OFFICIAL COORDINATION REQUEST FOR NON-ROUTINE OPERATIONS AND MAINTENANCE

COORDINATION TITLE- 14BON03 Underwater video of lamprey behavior in BI serpentine section

PROJECT- Bonneville Lock and Dam Bradford Island serpentine section

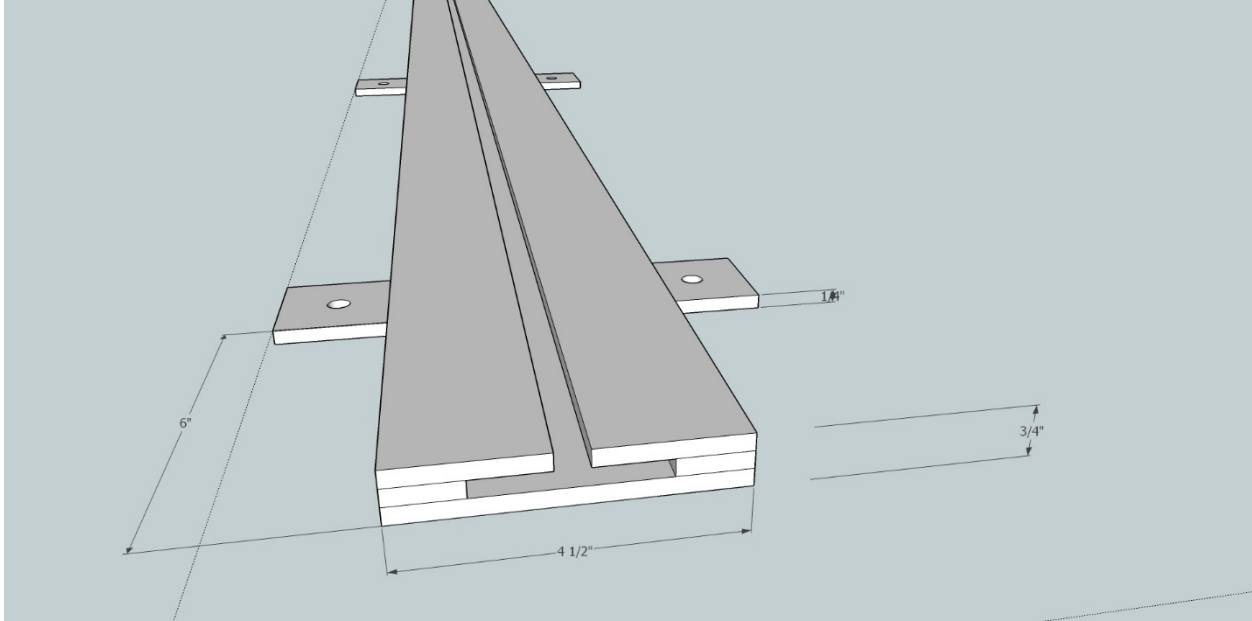
Additional feedback once photos (above) of the mounting channel were reviewed.

Don't know if trevor talked to you yet, but it seems that they could do a better job and run this along the concrete ball with out the overhang at the top of the bracket, or is this out of the water. Even if it is out of the water still not the best. This seems to be out in the flow more than I was expecting. I would strongly suggest they shift it back some. Sent this to our lamprey guy to see if this is any problem as well.

He had been recently told by his field crew that due to the inability to remove the grating above the I-beam channel it had to be installed at an angle and that the top part was sticking into the air above the fishway. The angle was required so the I-beam could be installed w/o removing the grating.

I was a little surprised to see how far two of the four channels lean away from the smooth wall creating an edge. Looking closer it seems they are above the typical water line and likely had to be installed that way to facilities feeding the I-beam into the channel.

We have asked the researchers to cut off the overhanging portion and not have anything protruding into the flow, above water or not. We'll try to get a picture to folks once the mod is complete. Thanks for the feedback.

I've spoken to Jeff and he's spoken to Andy. He and Les plan to cut the beams flush so no more "stick-out" sometime tomorrow. Will also grind everything nice and smooth. Again, our apologies for the unexpected (and inappropriate) change in plans.

Their plan is to cut the rail's length so it no longer sticks out past the wall and then smooth the edges to protect fish. The work will likely be done by:
